STATE OF NORTH CAROLINA
DEPARTMENT OF TRANSPORTATION

Addendum No. 1
RE: Contract # C204039
WBS # 34243.3.2
STATE FUNDED
Polk County (I-4729A)
I-26/US-74/NC-108 Interchange Modifications in the Town Of Columbus

September 19, 2017 Letting

The following revisions have been made to the Roadway plans:

6/23/16

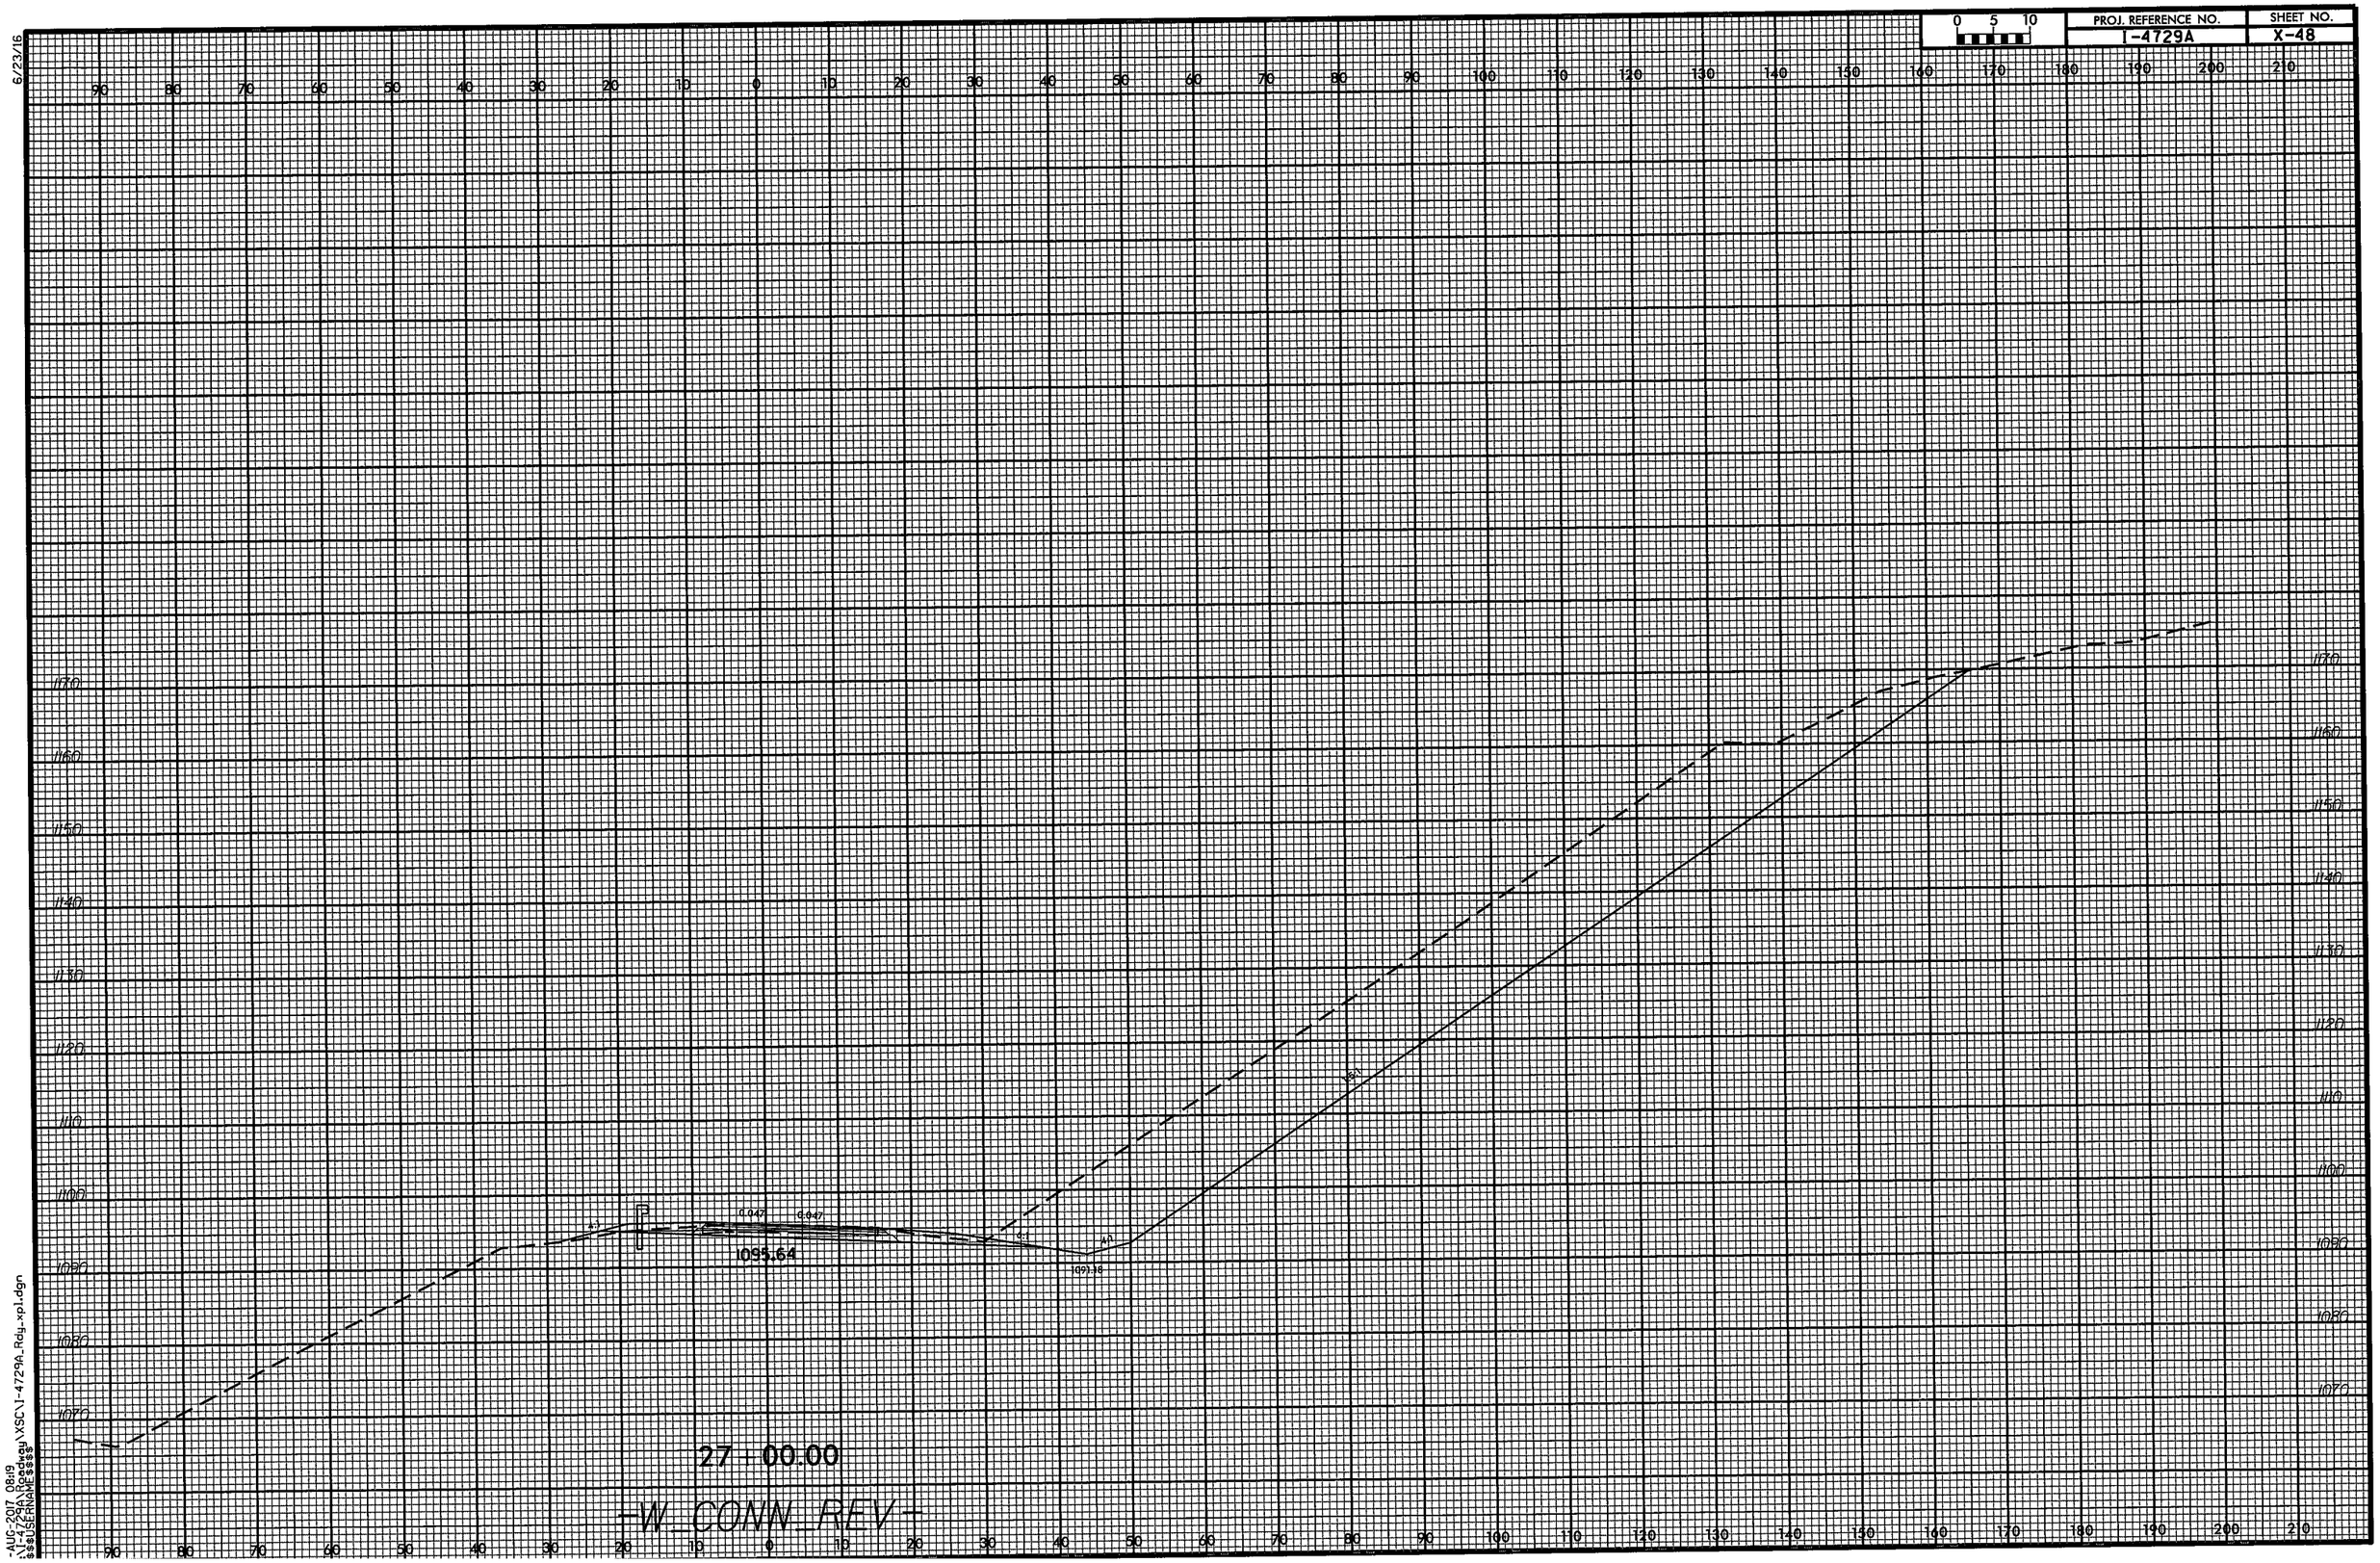
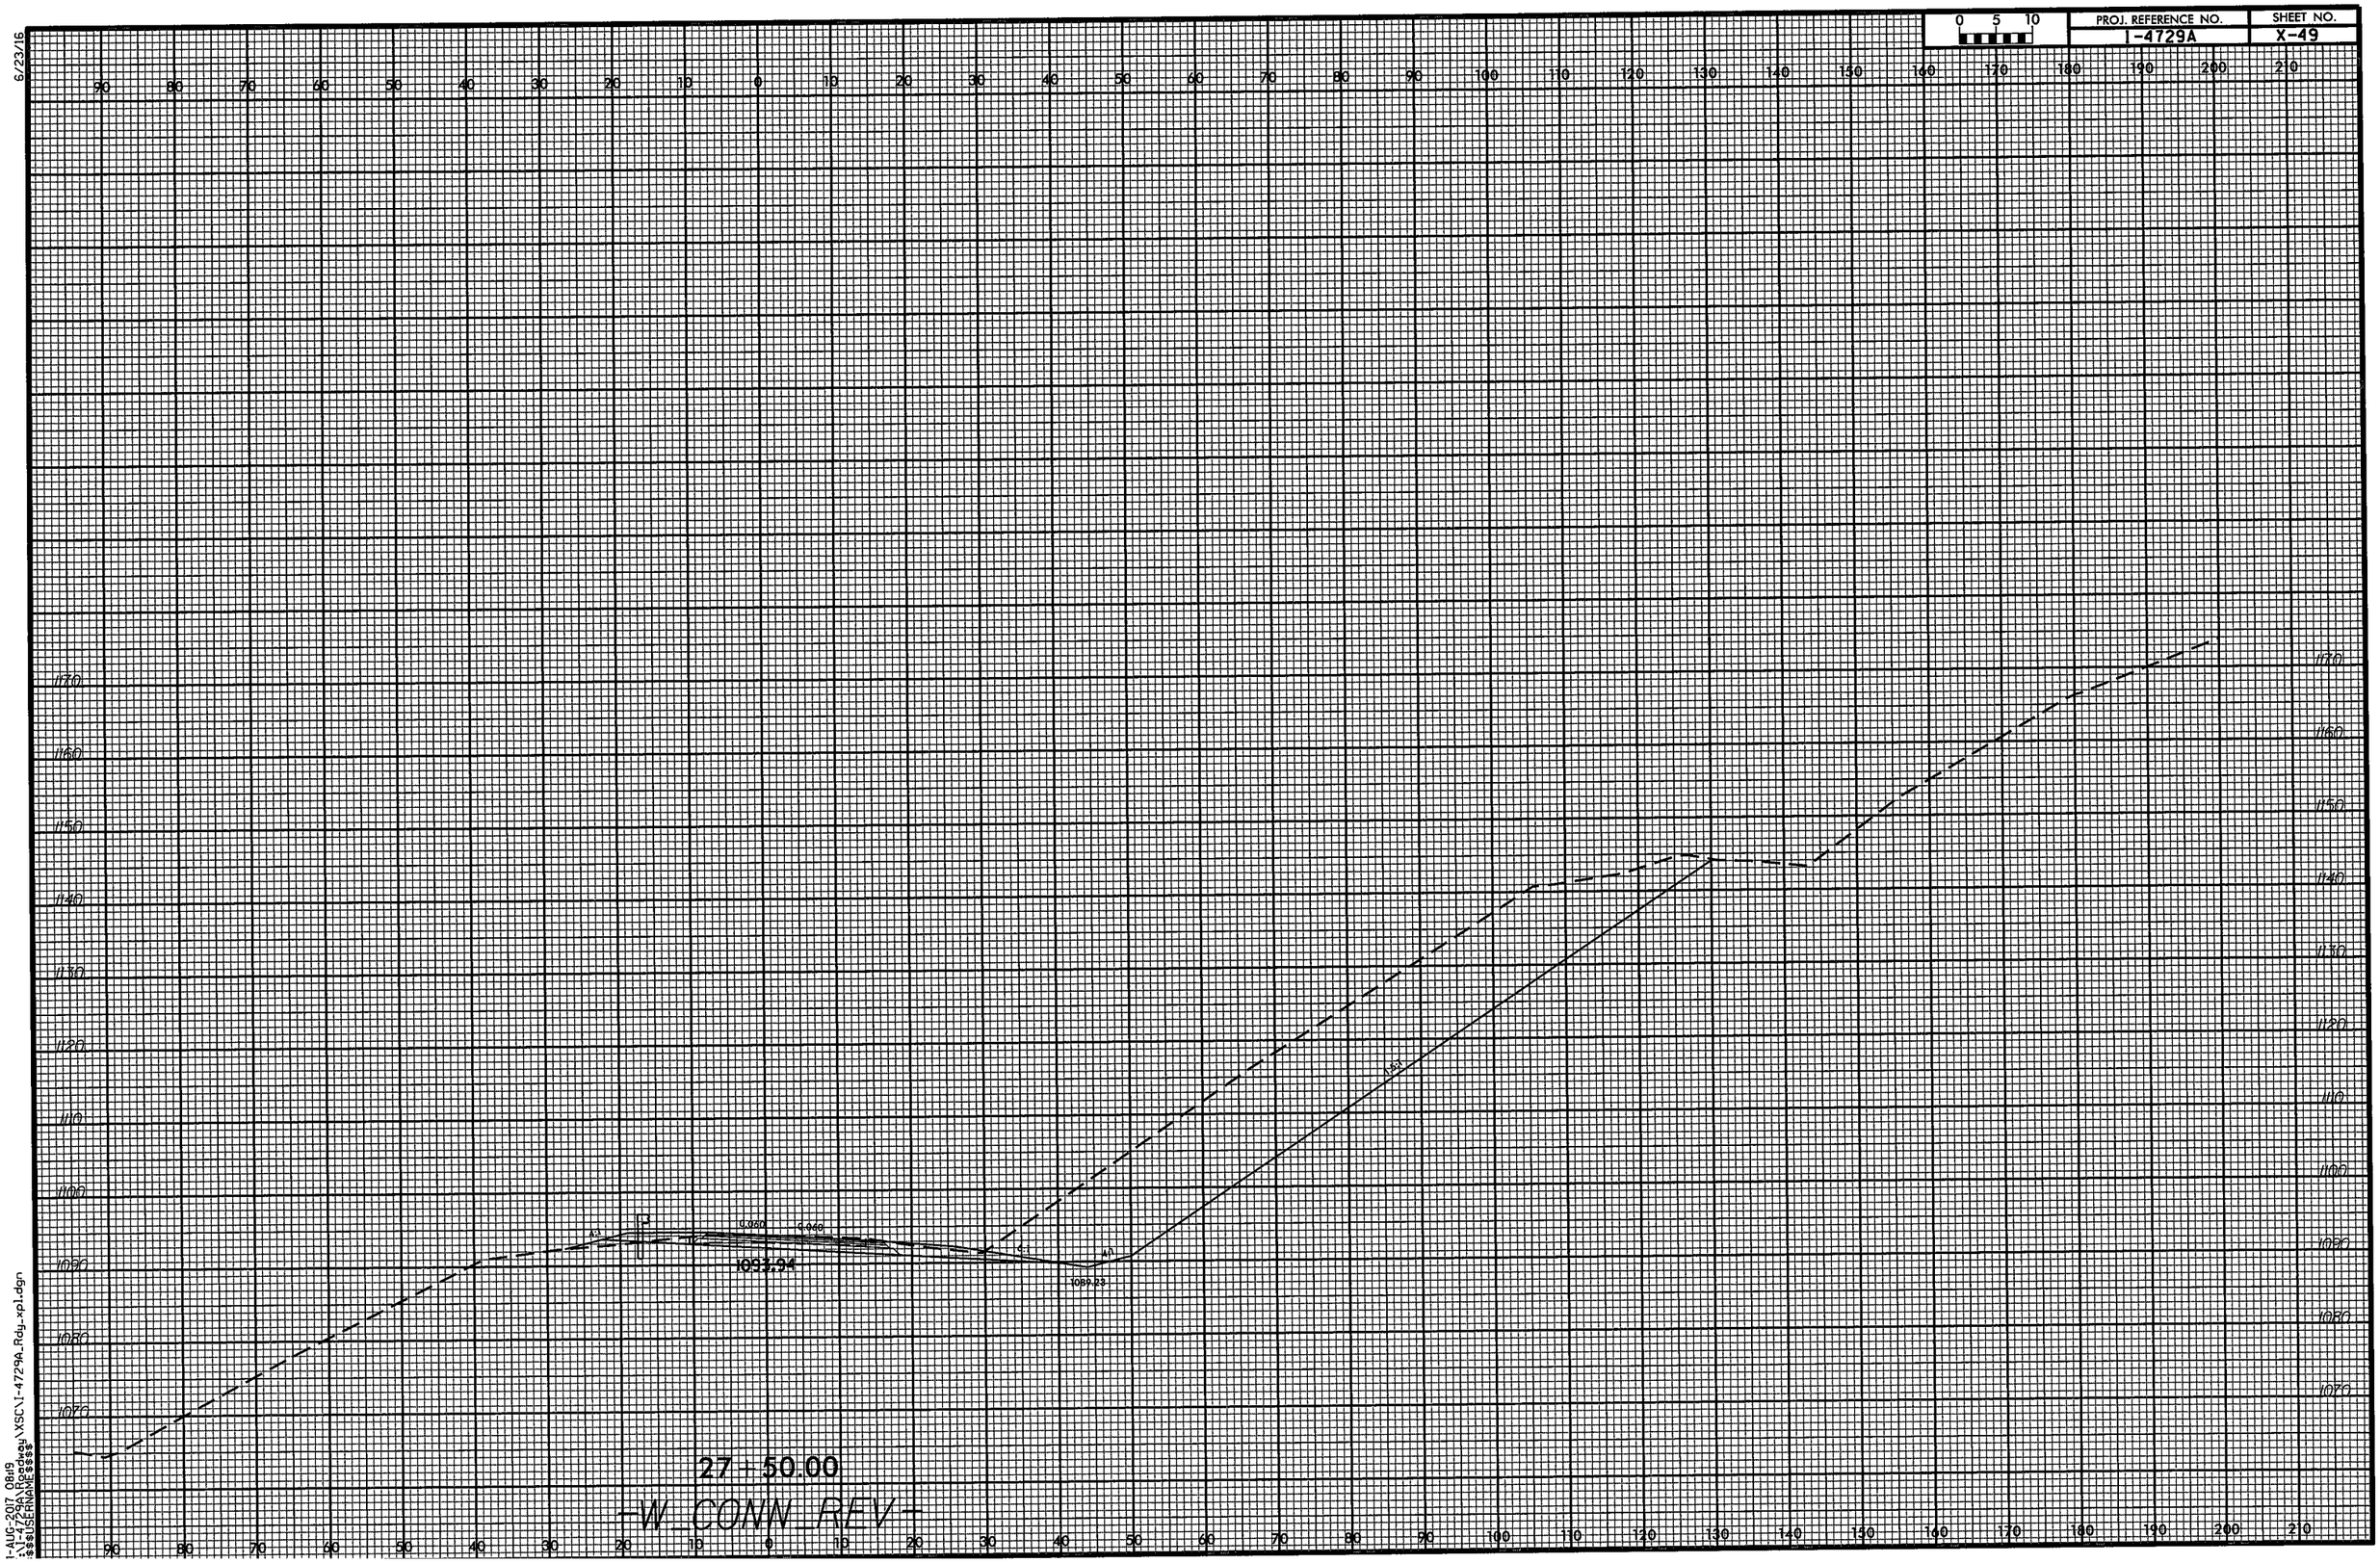
Sheet No.	Revisions
1A	Revised Index of Sheets to remove 2G-2 "Standard Embankment Monitoring Detail" and revise the number of" Drainage Summaries" sheets
2A-1, 2A-4 and 2A-5	Revised the Typical Sections for the change in mainline pavement widening design from ABC to Asphalt Base
3B-1	Revised 'Summary of Earthwork' to account for pavement widening design change
3D-1 thru 3D-4	Various drainage quantity changes as noted below
3G-1	Removed "Settlement Gauge Summary" and added note that Bridge Waiting Period only applies to Approach Slab construction
5	Revised to require Welded Steel Pipe by Trenchless method under the Interstate 26
X-1A thru X-87	Revised Cross-Sections to reflect the change in Earthwork due to the pavement design change
